Our ref : 10104/DJC/001

Outline Planning Application P/2017/0527 for Roadside Services Land West of Wrexham Golf Club, Holt Road, Llanpwl, Wrexham

I refer to receipt of a copy of highway comments dated 16 October 2017 regarding the above planning application. We have reviewed the comments and would wish to make the following comments.

ISO 9001 REGISTERED FIRM	Drawing Number 10104/001	Rev
--	-----------------------------	-----

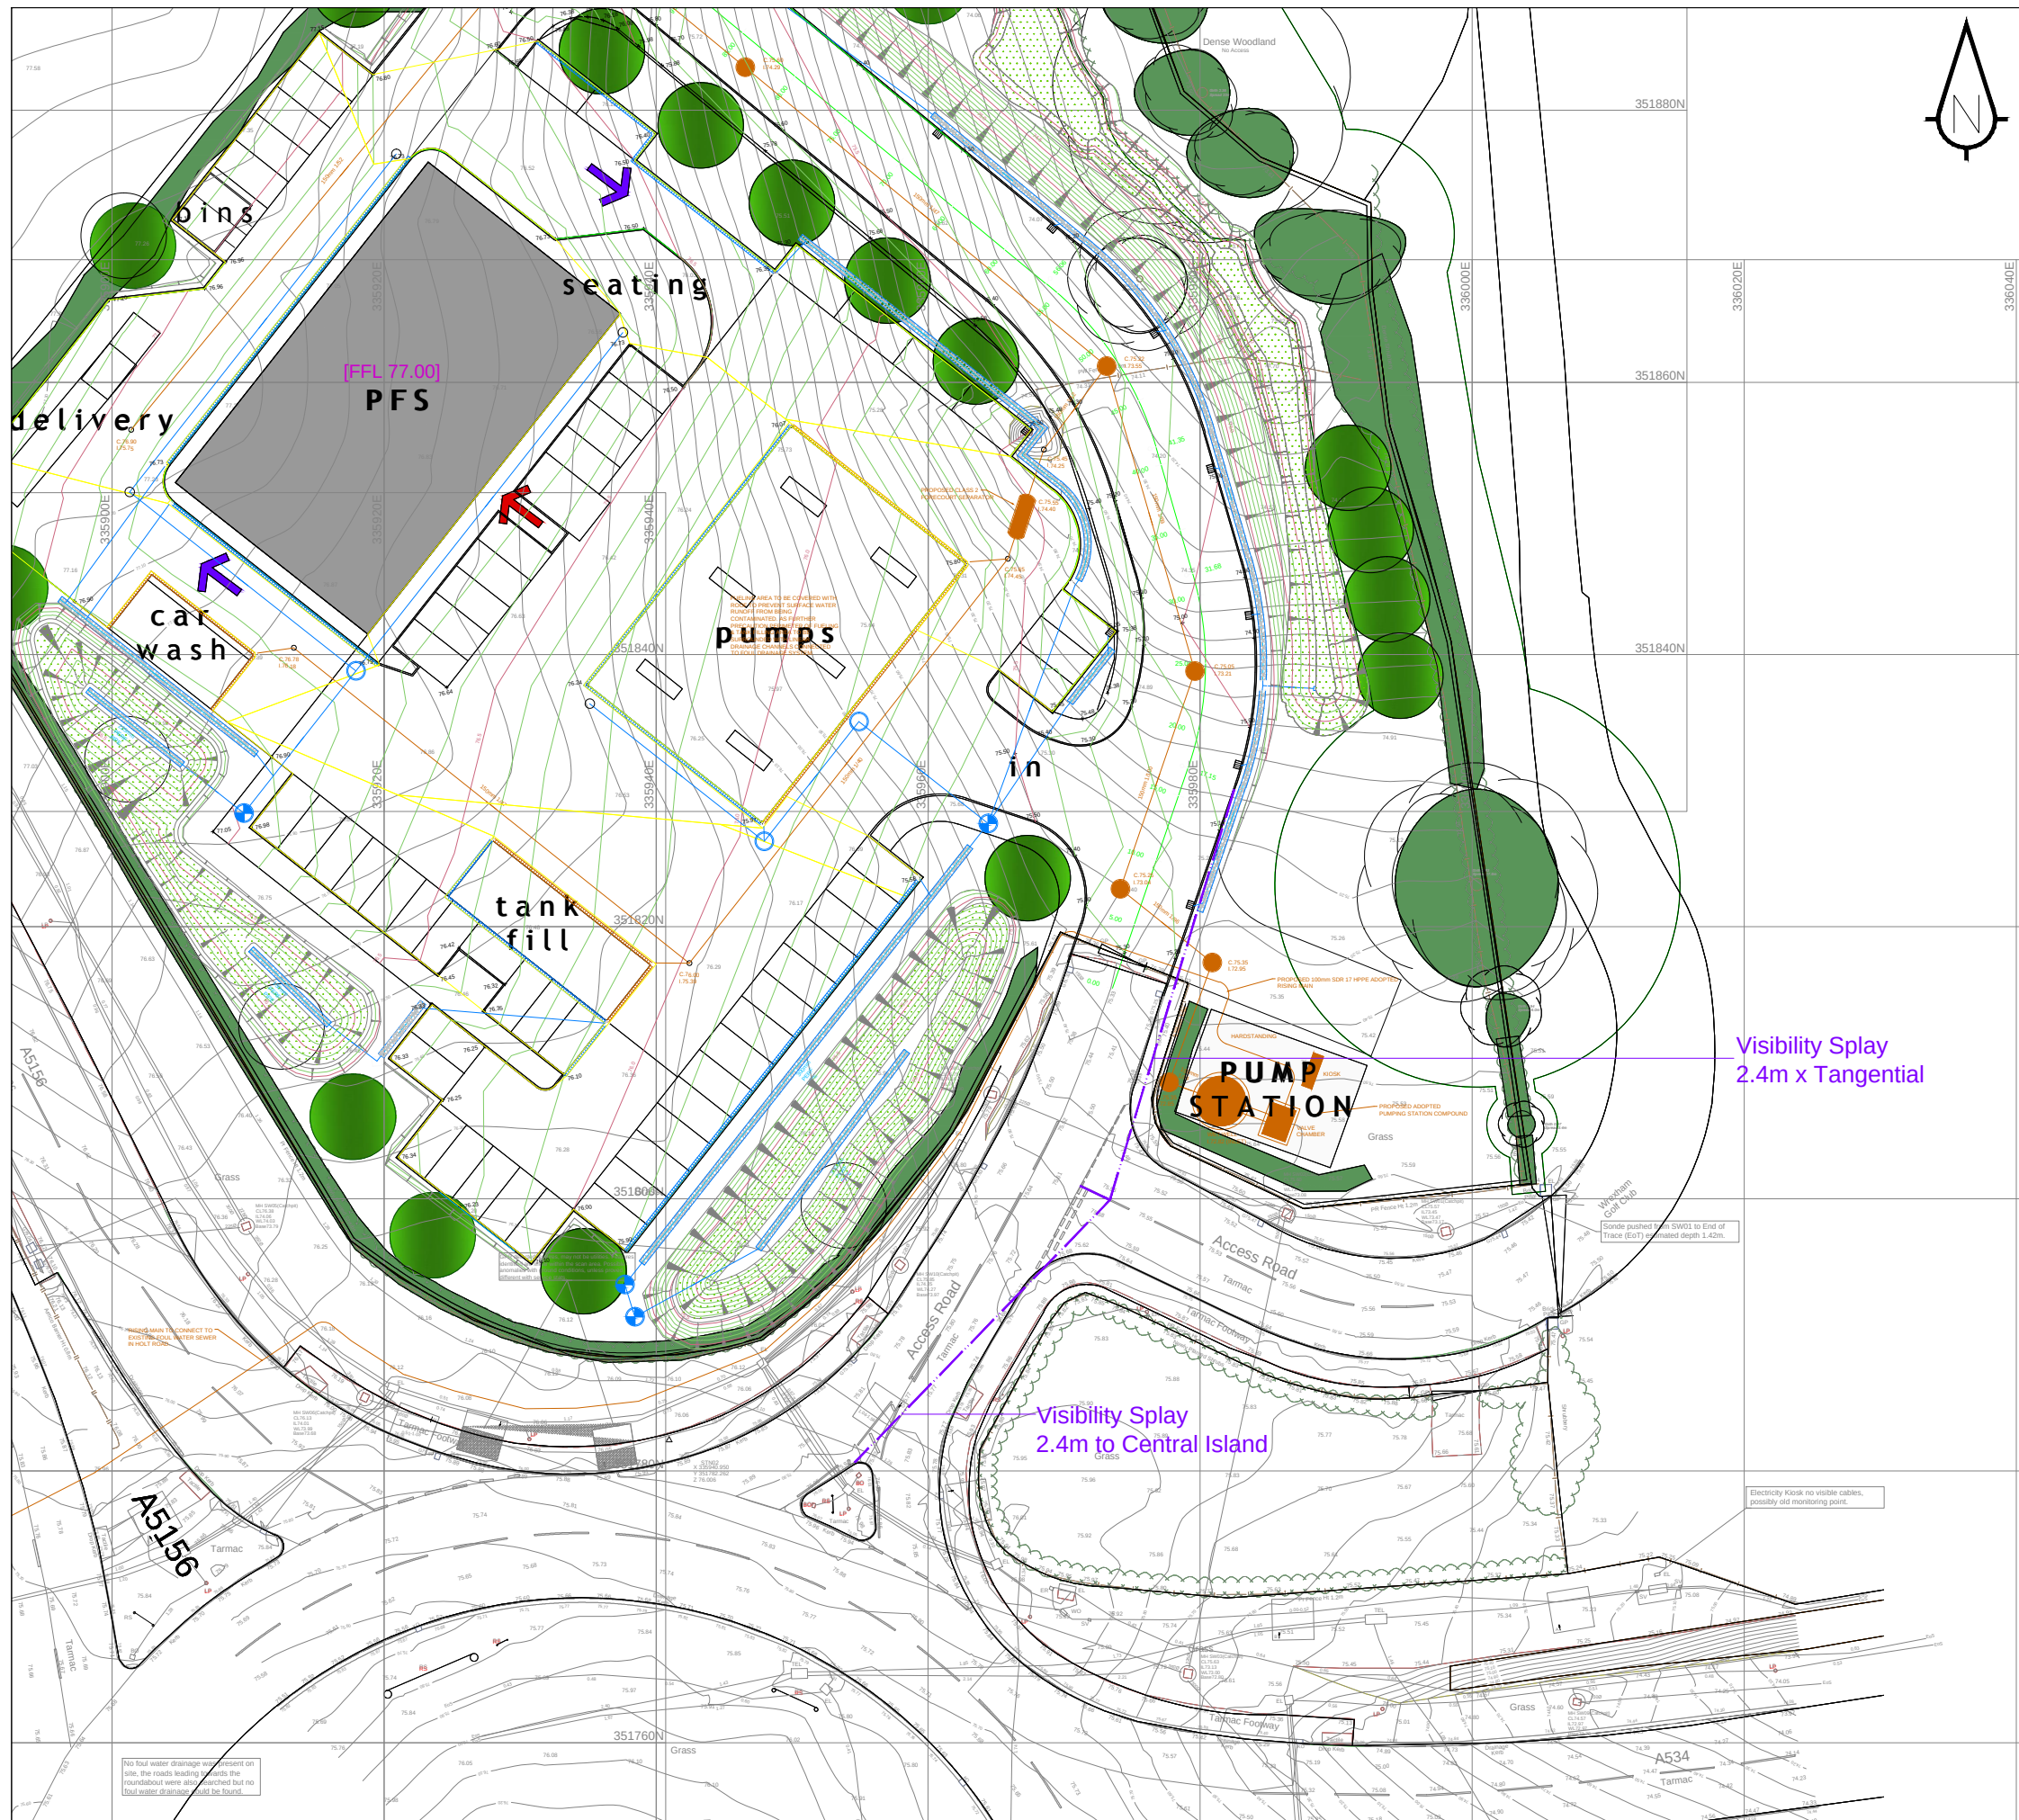
With regard to visibility splays for the existing Wrexham Golf Course access, this is not changed as part of the proposals and the visibility splays are shown on the attached drawing 10104/001. As indicated in the highway comments a splay of 2.4m x tangent is shown to the north east where approaching vehicles can be seen in excess of 33m from the access junction and visibility to the south west is shown to the central island since traffic is unlikely to enter the side arm from the roundabout on the wrong side of the island.

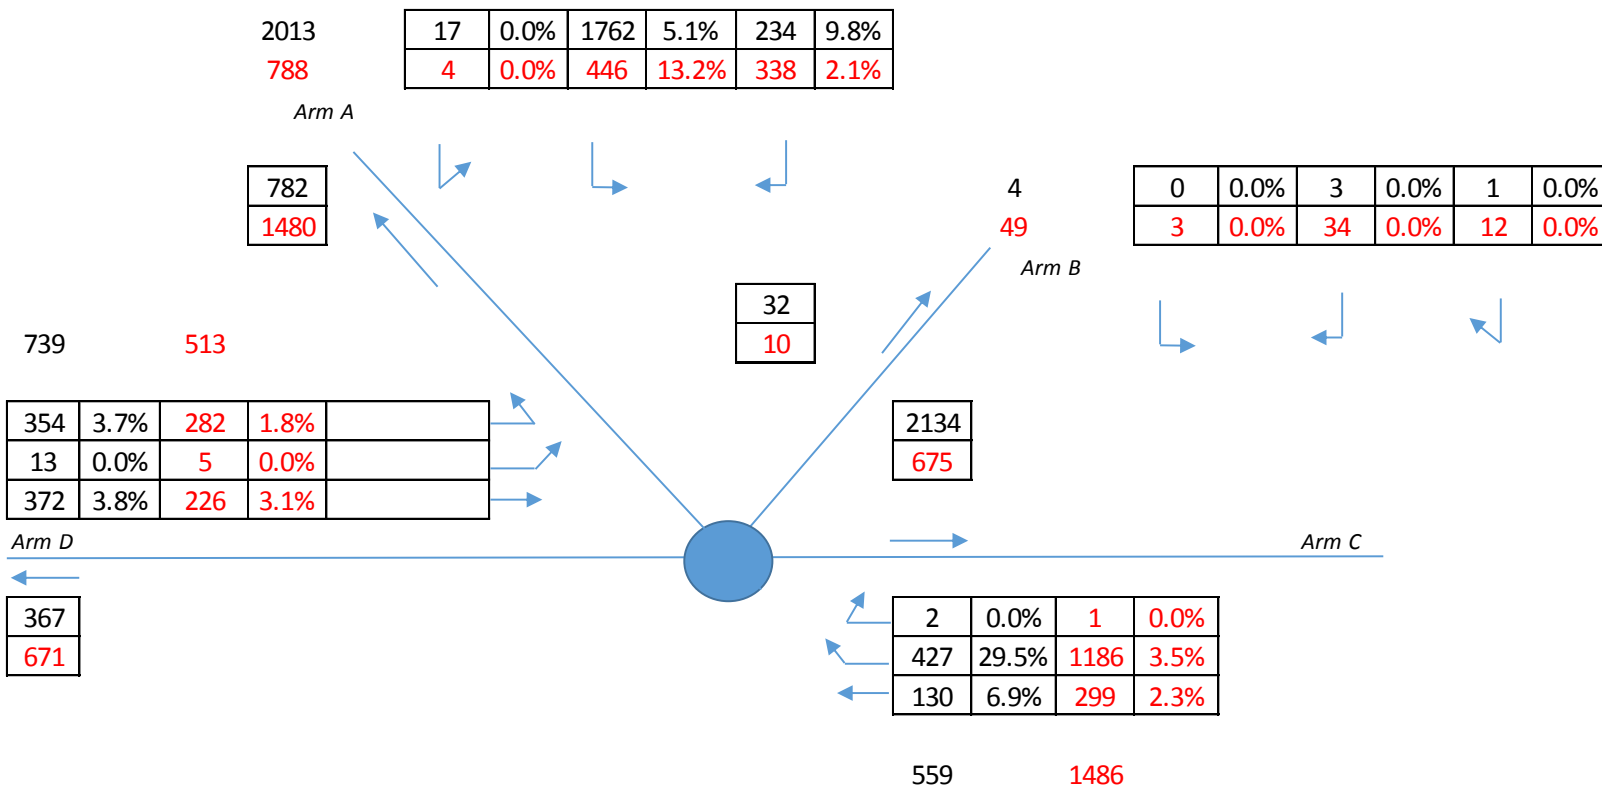
A new traffic count has been undertaken of the roundabout on the Thursday 16 November 2017 and the peak hour traffic flows are shown on the attached Figure 6A. The traffic flows on the A5156 northern arm of the roundabout are higher in comparison to the previous traffic count from May 2016 in the morning peak as well as smaller changes on Holt Road and the A534. There are also small differences in the PM peak period. This data has been used to review the traffic capacity modelling of the roundabout.
